CITY OF SOMERVILLE, MASSACHUSETTS
MAYOR'S OFFICE OF STRATEGIC PLANNING & COMMUNITY DEVELOPMENT
JOSEPH A. CURTATONE
MAYOR

Case #: PB 2013-08

UPDATED PLANNING STAFF REPORT*

Site: 181 & 197 Washington St

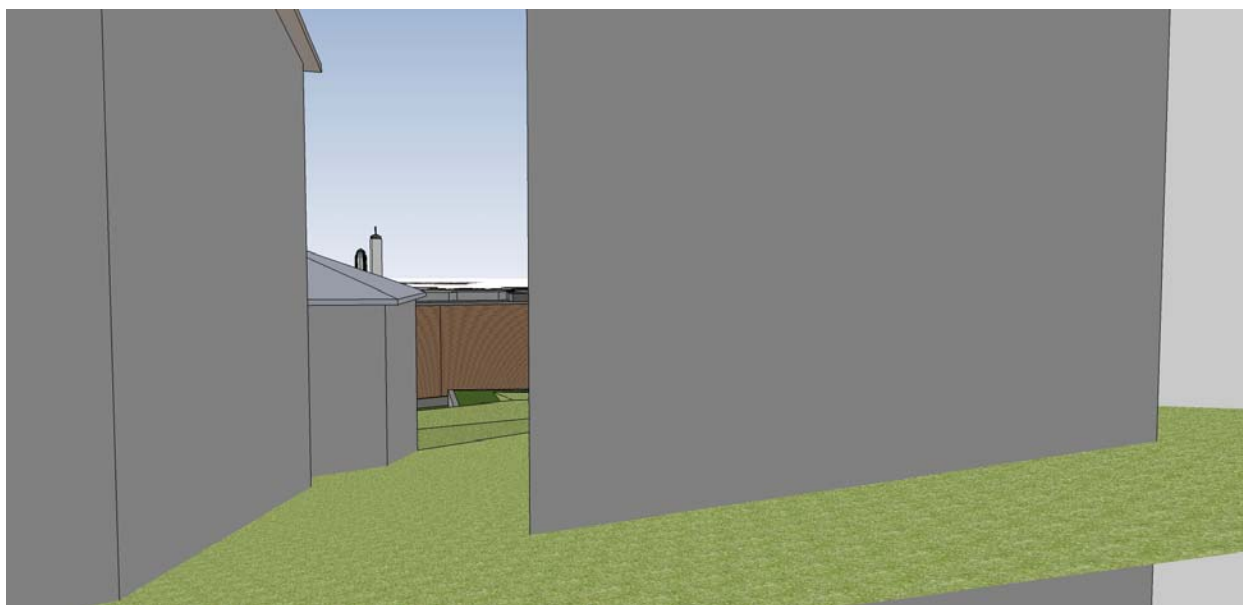
Design Review Committee: The applicant presented to the DRC on May 9th. The following are two of the images presented and subsequent minutes from the meeting.

The DRC recommended the following:

- Develop an upper story setback. This will reduce the scale of the building and will break up the elevation.
- Complete the metal panel on the 5th story to give the appearance of a 'top.'
- Redesign the Boston Street side plaza retaining wall to maintain visual accessibility of plaza.
- Develop and strengthen the vertical separation in the elevation.
- The elevation is reading as planar and flat. Projection and recesses will help break up wide expanses of the same material.
- The DRC appreciated the deeper profile of the Hardie Artisan product and neighborhood context of the material.
- The storefront design will be reviewed with the DRC prior to the Certificate of Occupancy or when a tenant is signed.
